Subject: Vietnam Veterans Memorial Center- consultation on proposed security measures

RE: Vietnam Veterans Memorial Center; Proposed Installation of Additional Egress Path & Security Bollards

RE: Vietnam Veterans Memorial Center; Revised Design for Proposed Installation of Additional  
Egress Path & Security Bollards

RE: Vietnam Veterans Memorial Center; Revised Design to Eliminate Entryway Wall, Eliminate an Additional Skylight, Simplify Ground Plane Planting & Relocate One Tree

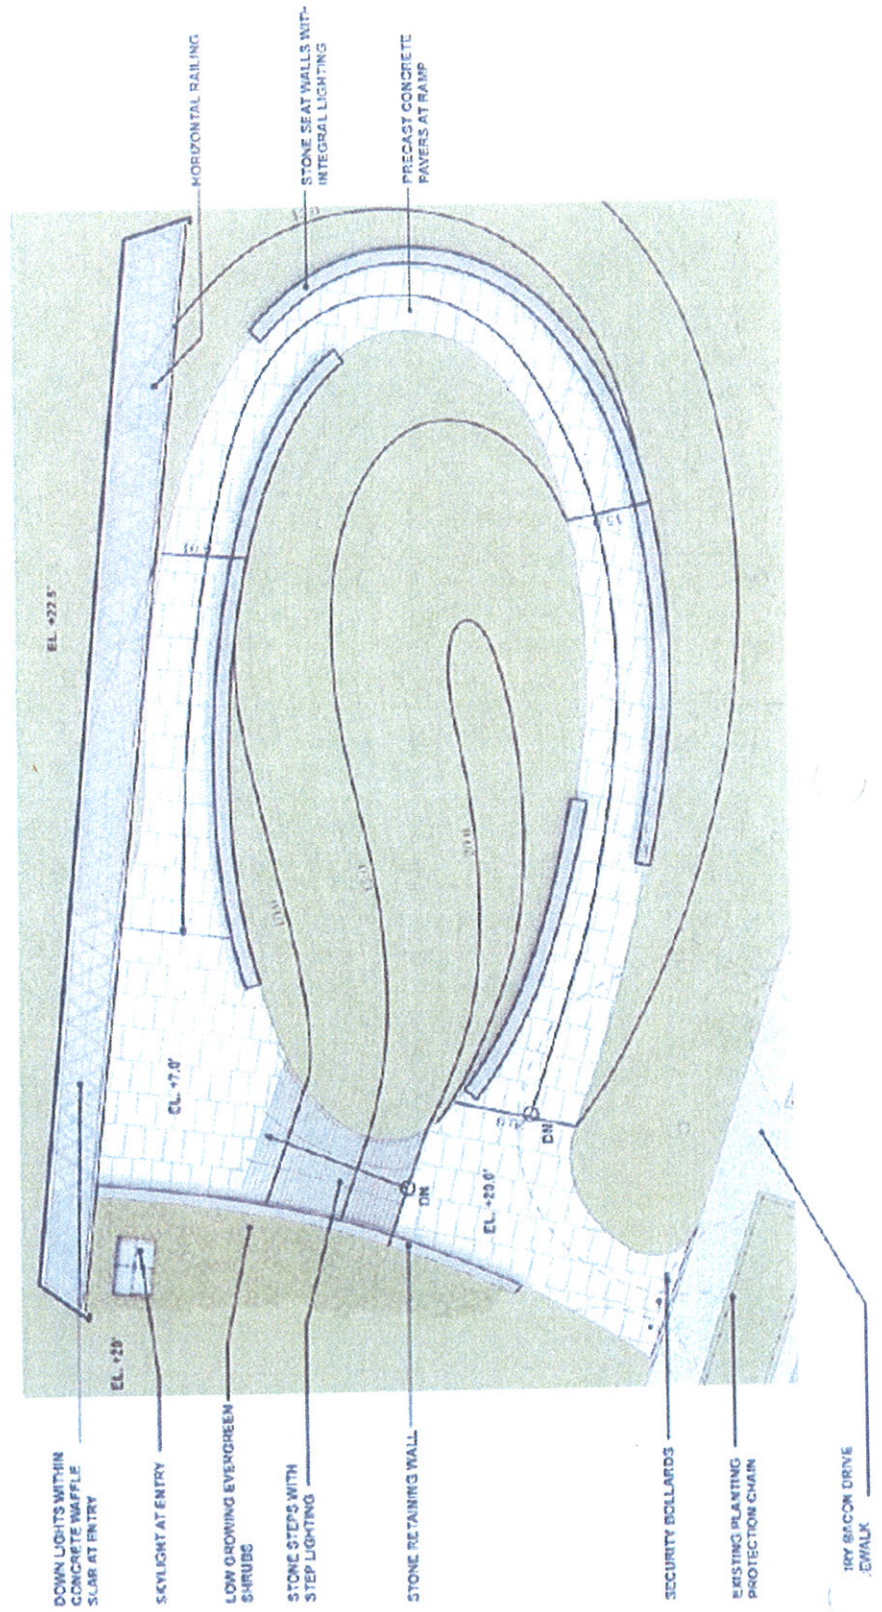
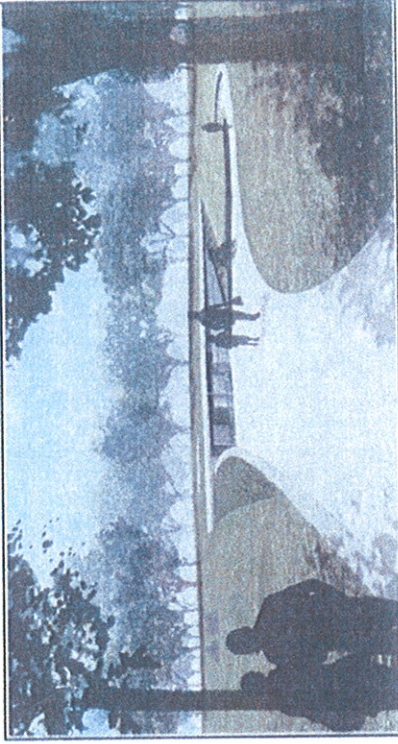
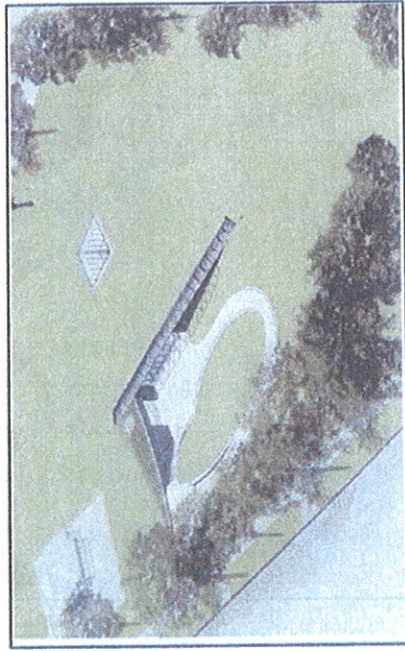
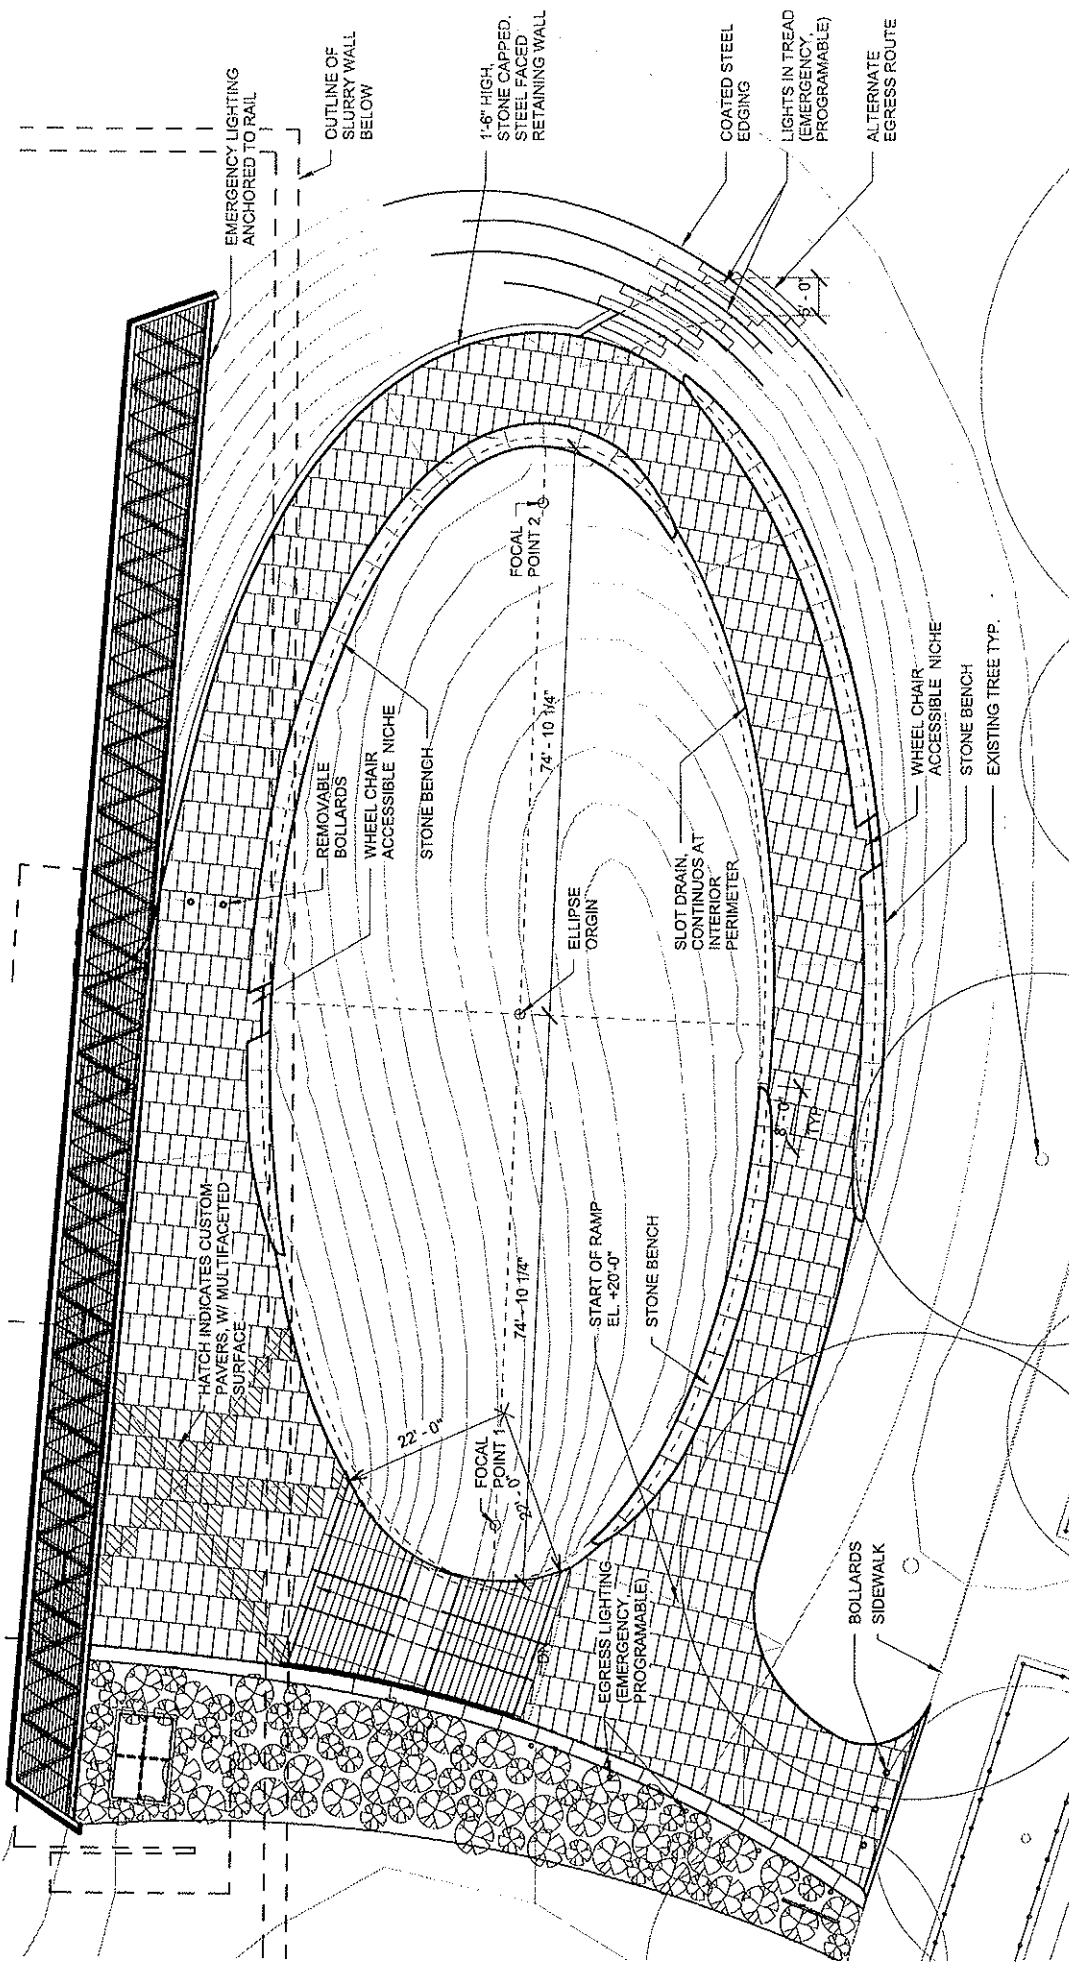
The stone benches along the elliptical walkway serve as vehicle deterrence. In consultation with park staff, the National Capital Region Fire and Emergency Program Manager, and the US Park Police, the design has team identified the following additional measures as necessary for life safety and errant vehicle protection (see enclosed):

- a) An additional path off the entry walkway would allow for an alternate emergency exit route from the depressed entry plaza, as required by National Fire Protection Association code. This path would be 5 feet wide and curve slightly up the grade from the plaza towards

Henry Bacon Drive, but would end after approximately 24 feet. Four bands of coated steel edging would extend out in order to retain the terraced lawn around alternate path's treads and to integrate the stairs into the landscape. Emergency lighting would be provided along this egress route. The lights would be in tread, and programmed to illuminate during emergencies only.

- b) Because a portion of the stone bench would need to be eliminated to provide for this access, additional errant vehicle protection would be required. A pair of removable bollards, compatible with the stone walkway, would be placed at the end of the walkway, before it opens up to the entry plaza.

Based upon your recent letter and on-going conversations with NPS staff, we understand that two such revisions have been proposed by the NPS. These revisions, which are intended to address safety concerns that were only recently identified, include: 1.) an additional emergency egress path off the entry walkway that would include bands of coated steel edging along the path's treads; and 2.) a pair of removable bollards that would be inserted at the end of the walkway.

Although the NPS has determined that these revisions will not constitute a new or intensified adverse effect, we are unable to concur with the NPS determination at this time. We understand that a meeting was held to discuss the proposed revisions with CFA and NCPC on March 14<sup>th</sup>, 2013. Unfortunately, we were unable to attend but have been informed by NPS staff that the proposed revisions were not favorably received. As a result, the project architects have been charged with making refinements that will better integrate the new egress path and bollards into the overall design. We strongly encourage the NPS to also ensure that the newly proposed elements will not be visible from the Lincoln Memorial or from other historic properties within the APE.

As you may recall, we wrote to you on March 22, 2013 to express our initial concerns about the proposed designs and to notify you that we were unable to concur with the NPS determination that the additional egress path would result in no new or intensified adverse effect on historic properties. However, based upon our review of the revised plans (see image to the right), we are now able to concur with that determination. As such, no further consultation with our office will be necessary regarding this particular aspect of the Vietnam Veterans Memorial Center.

# RECONSIDERED DESIGN: Site Plan

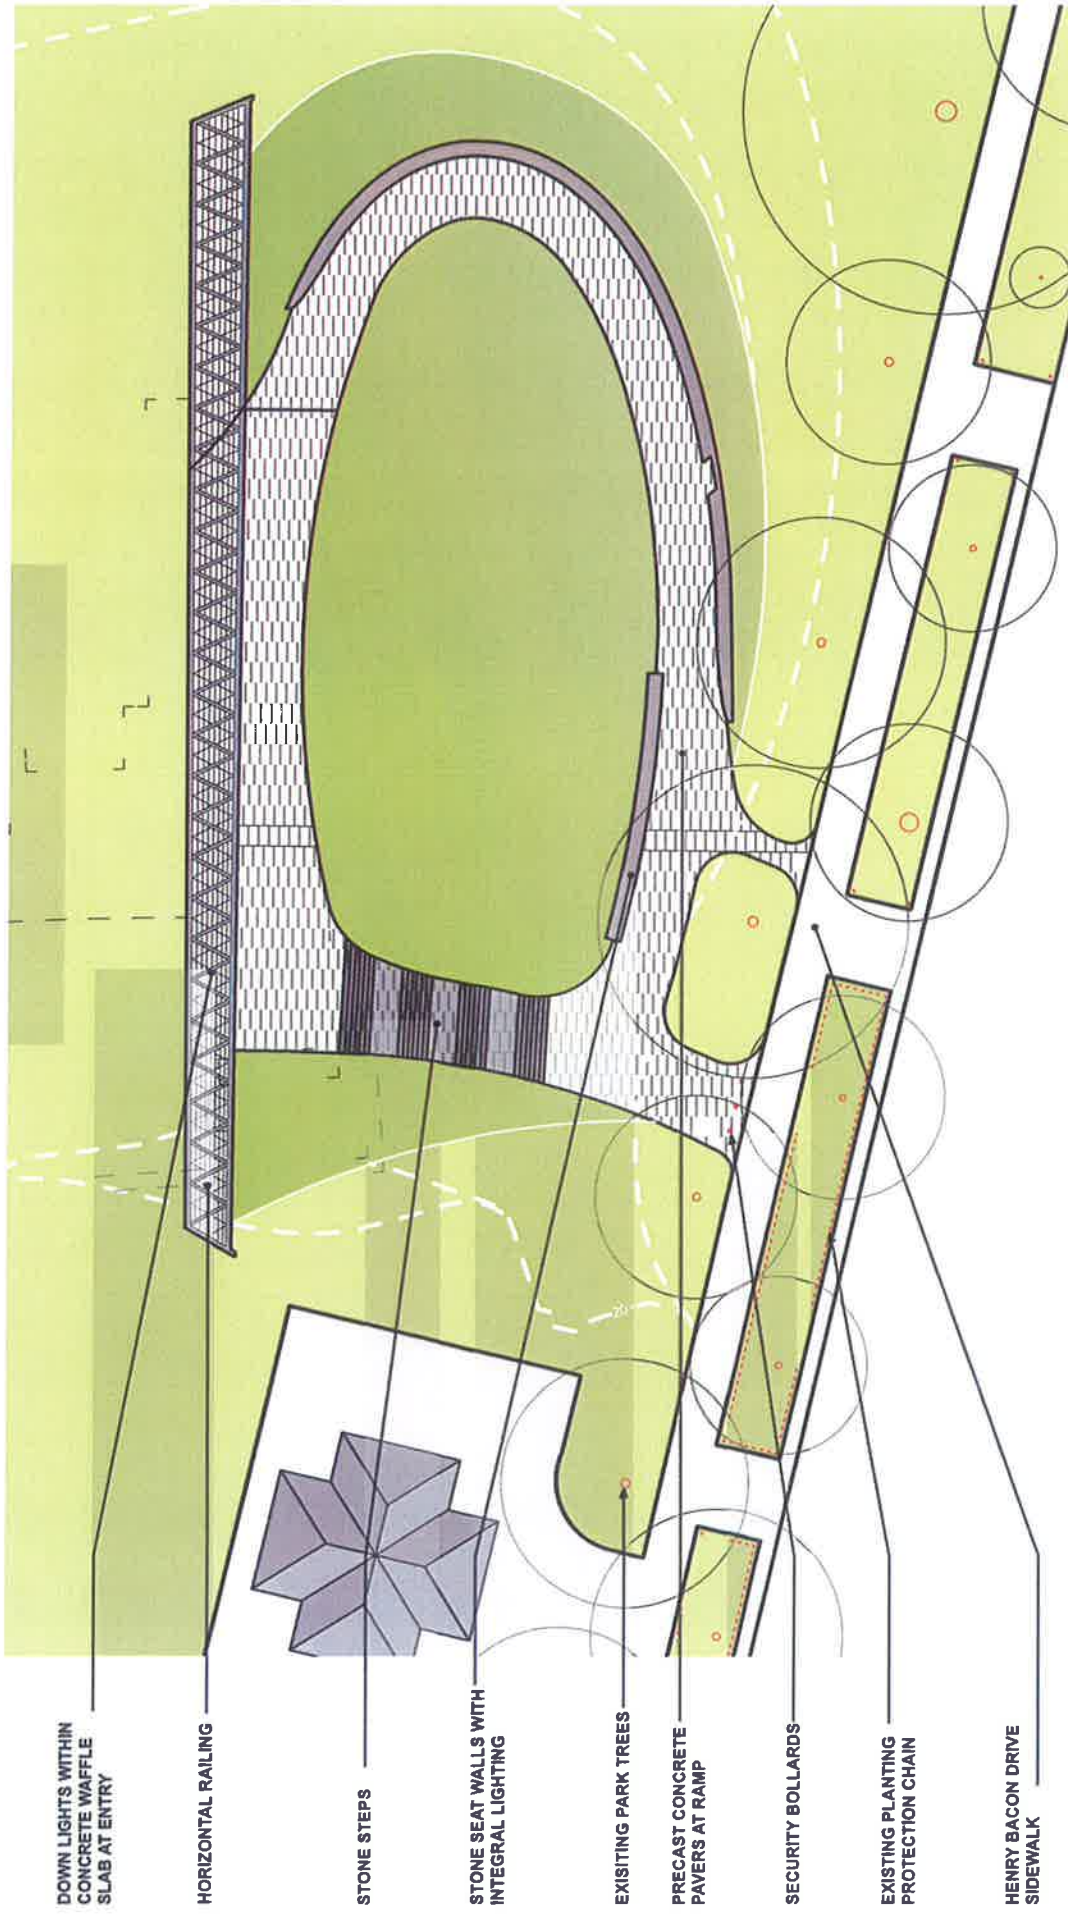
The Commission of Fine Arts (CFA), at its April 2014 meeting requested further study of the entry experience to the memorial center. In response, the Vietnam Veterans Memorial Fund consulted with the design team and presented an amended study to the Commission of Fine Arts at its July 2014 meeting. The study was well received and has resulted in the removal of the wall along the entrance way, the removal of yet another skylight portal, and the simplification of the ground plane planting. Since July, we have coordinated the revised entry scheme to meet access and security concerns, the result of which has been the adjusted location of one tree within the historic tree planting plan. We have enclosed a graphic presentation that shows the current state of the project to fulfill the responsibilities of the 2012 MOA.

Based upon our review of the most recent plans, we understand that designs which we commented upon on January 16, 2014 (image below on the left) have been revised so that the wall along the entryway and one additional skylight will be removed, the ground plane planting plan will be simplified and one additional tree will be planted for security reasons (image below on the right). As before, we concur with the NPS determination that these additional revisions will not result in any new or intensified adverse effect on historic properties. Therefore, no further consultation with our office will be necessary regarding the revised designs.
